**RE: Tract 3, Paradise Plaza  
Grading Plan  
Stamp Date: 7/7/17  
Hydrology File: A11D012A**

**RE: TRACT 3, PARADISE PLAZA – HYDROLOGY FILE A11/D012A**

Included with this response is a copy of the revised Grading & Drainage Plan set for the above referenced project. Revisions were made based on your review comments dated June 10, 2017. Following are numbered responses corresponding to your numbered comments:

CG-101

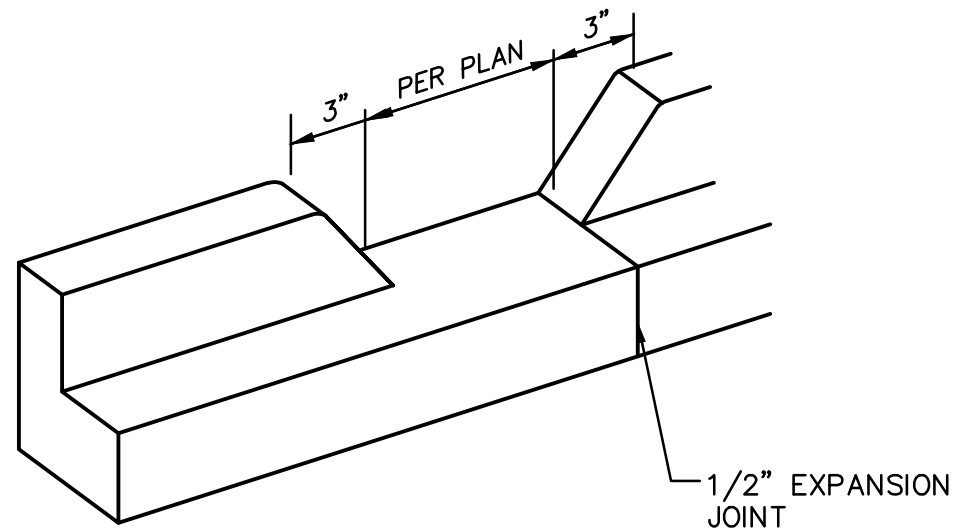
2. Drainage Plan Concept summary revised on CG-101.
3. First flush note revised to reference Supplemental Drainage Information for Paradise Plaza (Tracts 1, 2 and 3) by Isaacson & Arfman dated 08/14/08.

6. The viewport on Sheet CG-101 has been expanded to show additional off-site information.
7. The detention volume for the pond as well as the design calculations are provided in the Supplemental Drainage Information for Paradise Plaza (Tracts 1, 2 and 3) by Isaacson &

CURB OPENING

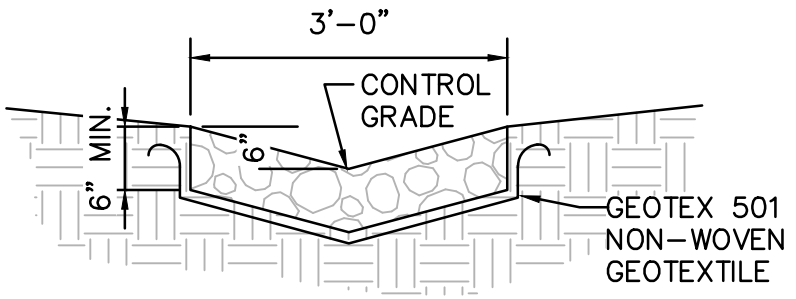
8. First flush note added to CG-501.
9. The rock erosion protection is for the minor swale within landscaping (for Basin B) with a peak flow rate of 2.1 cfs. Per the detail note, the required rock will be angular face between 2" and 6" (avg. 4"). A channel analysis (see attached) shows a depth of 0.38' with a velocity of 2.42 ft/s. The same erosion protection size will be used at the curb openings (keyed note 13).
